RECALL 21V-298: FRONT SEAT SAFETY BELT BUCKLE

This Service Information Bulletin (Revision 3) replaces SI B72 02 21 **dated May 2021**.

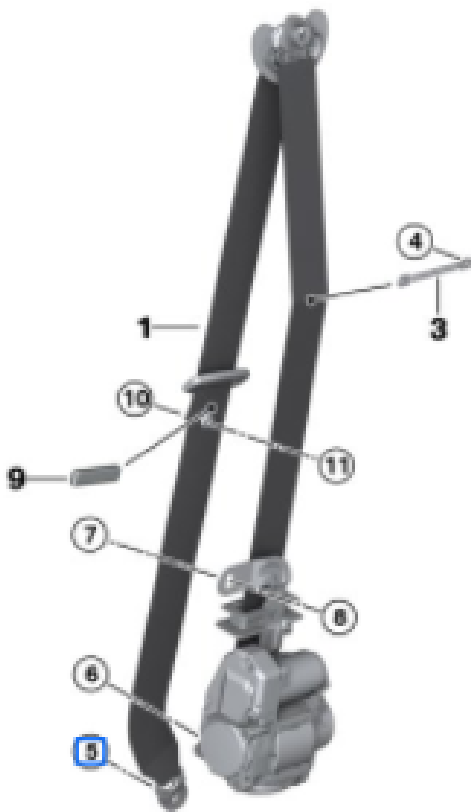
<p>Check the bolt connection of the lower safety belt (belt buckle) on both front seats for correct screw connection.</p> <p>It is not necessary to remove the seats for this.</p>
	<p>Check whether the bolt for the lower safety belt buckle is in contact with the seat frame.</p> <p><b>Note:</b> Do not retighten or tighten the bolt.</p> <p>If the bolt is not screwed into contact with the seat frame, then the bolt must be replaced according to the repair instructions 72 11 255 Front lower belt.</p>

If removing the seat from within the vehicles interior to make the buckle repair, then additional bolt (5) 07 11 9 908 419 will have to be removed and replaced.

This bolt retains the bottom of the safety belt to the side of the seat.
